May 10, 2007

**Subject:** City of Rohnert Park Comments on Draft Environmental Impact Statement (DEIS) for the Graton Rancheria Casino and Hotel

**Figure 2.2-1**  
**General Plan Diagram**  
Adopted July 2000  
(Rev. 4/07)

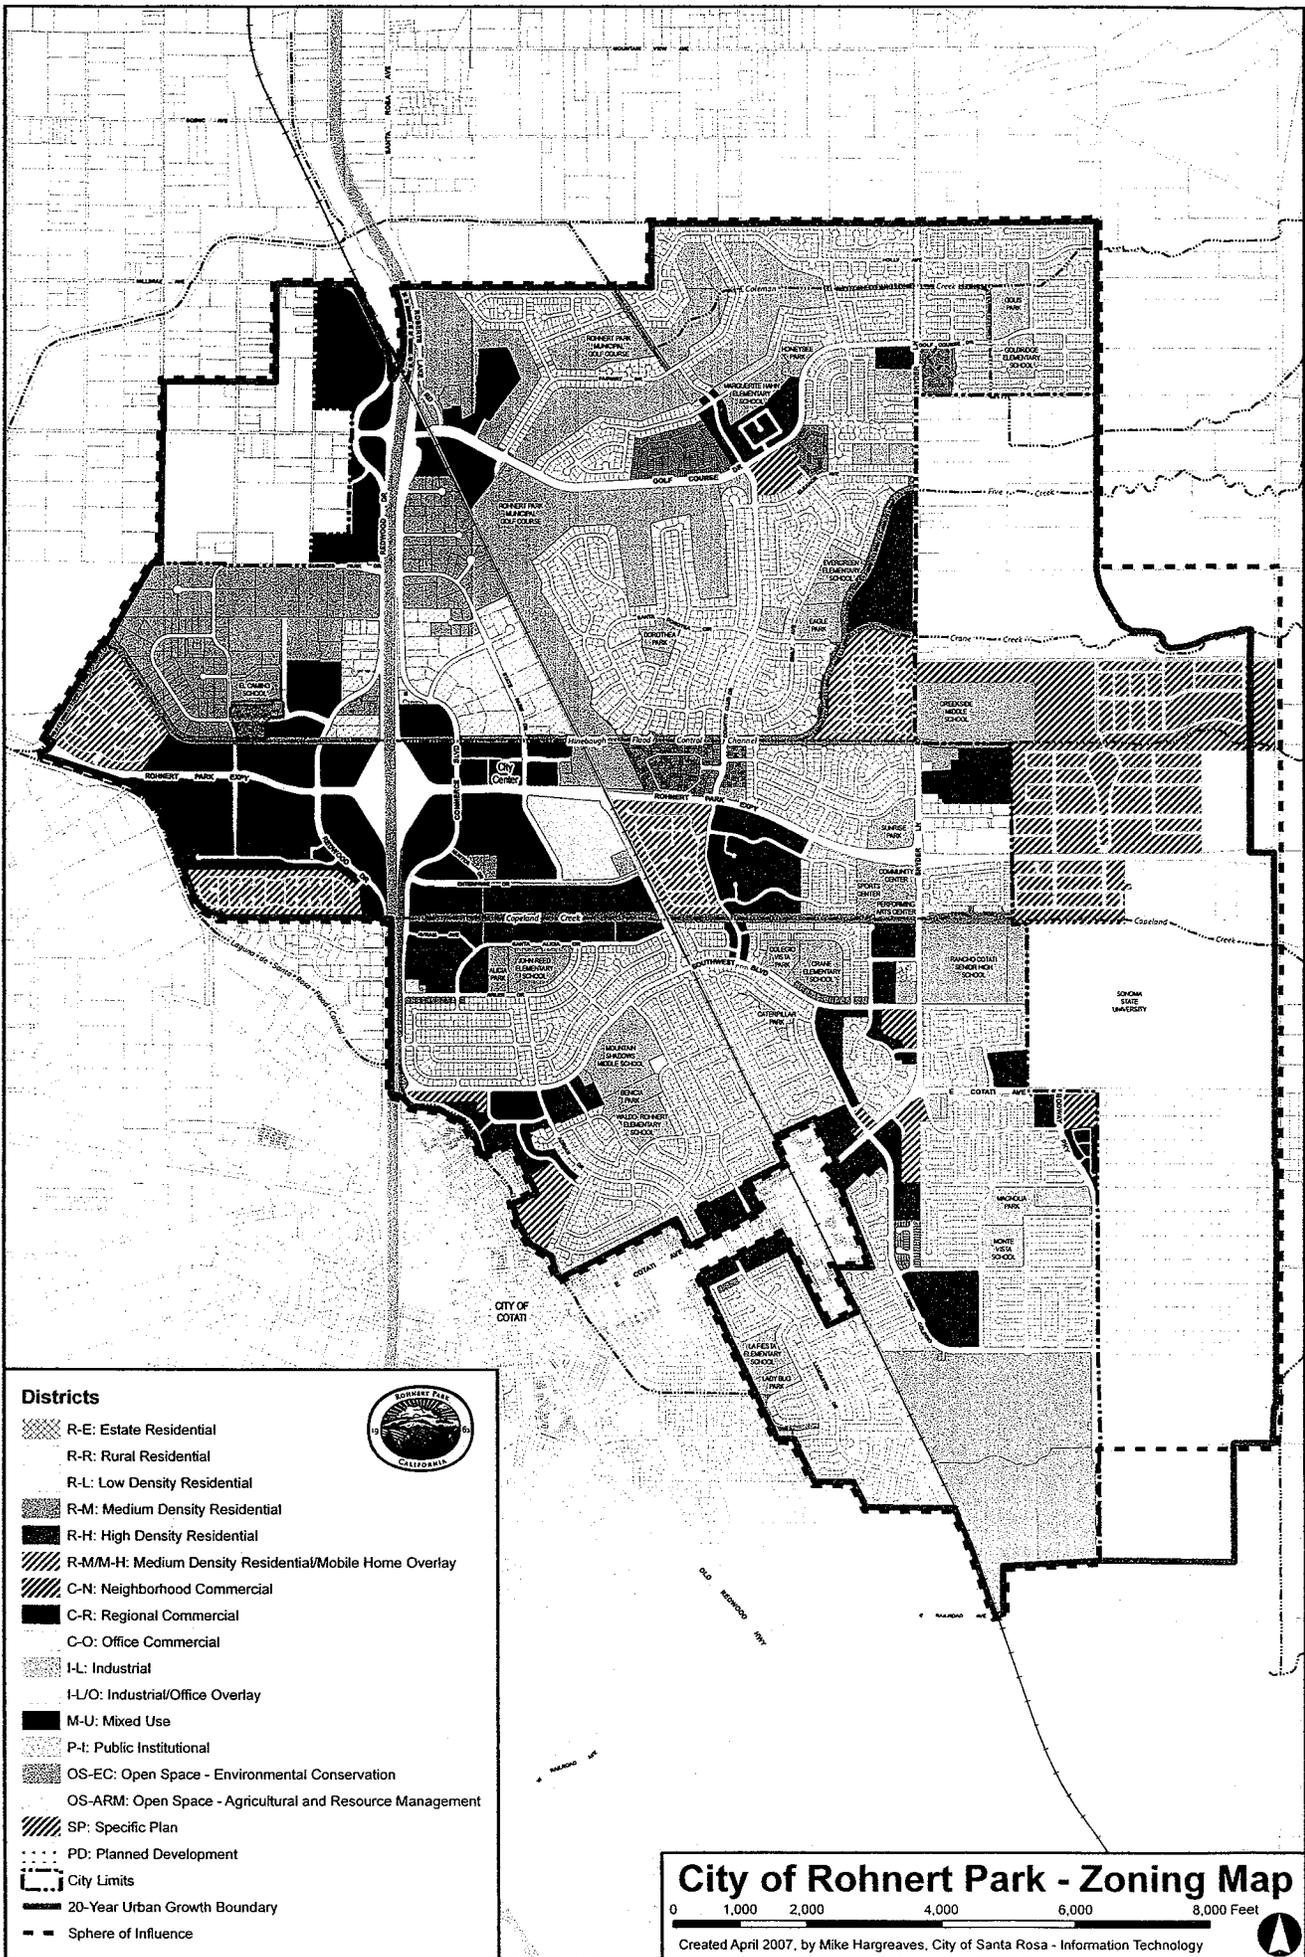
- Page 3.8-32: There should be a bullet point added regarding the City’s agreement with the County regarding Community Separator mitigation.
- Figure 3.8-12 is inaccurate and should be updated (see attached Zoning Map).

- Page 4.12-4, last paragraph: It should be noted that the "Luther Burbank Center" is now the "Wells Fargo Center."
- Figure 4.12-3: This graphic inaccurately represents the planned developments in the area and should be updated to reflect the existing plans and the current General Plan (see attached).
